**Total Maximum Daily Load  
To Address Biological Impairment in**

**Rugg Brook (VT05-07)**

**October 2008**

Appendix A: Summary of Responses to Public Comments

**Figure 5.** High flow portion of the flow duration curves for Rugg Brook and attainment stream.

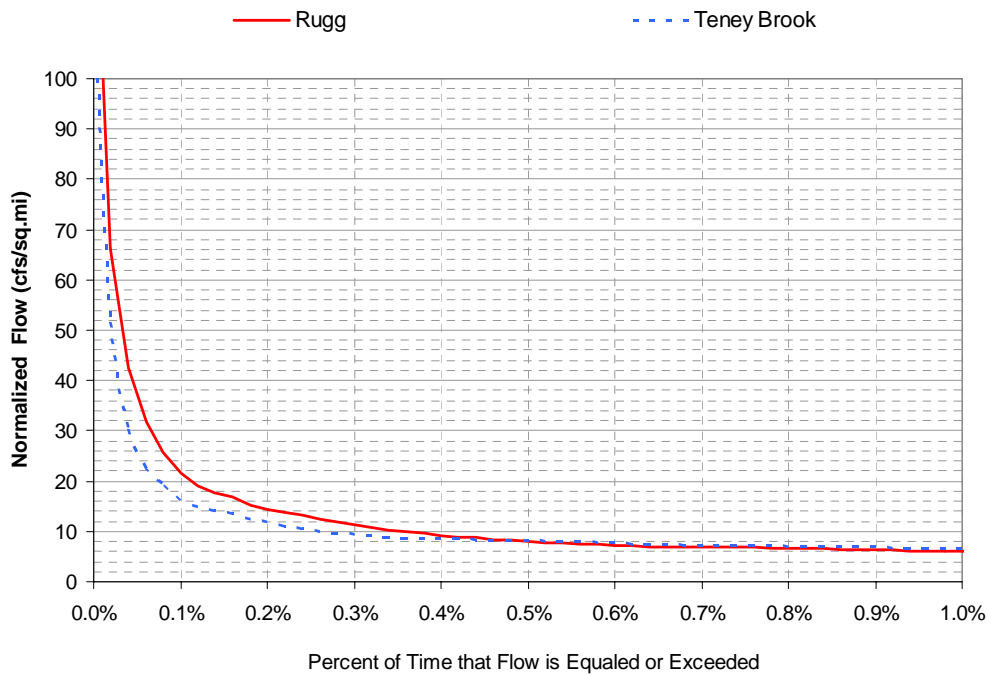
4. Page 14. The coincident of the graphs in Figure 5 does not seem to support a significant expenditure of resources to reduce stormwater related flows in Moon Brook. [Rutland]

Response: As noted in the TMDL, the high flow reduction target from current modeled conditions is 12%. Across the spectrum of the stormwater impaired streams for which TMDLs have been developed, this percent flow reduction is relatively modest. However, at this time watershed-specific implementation planning and cost estimates have not been developed to estimate the resources required to achieve this target.
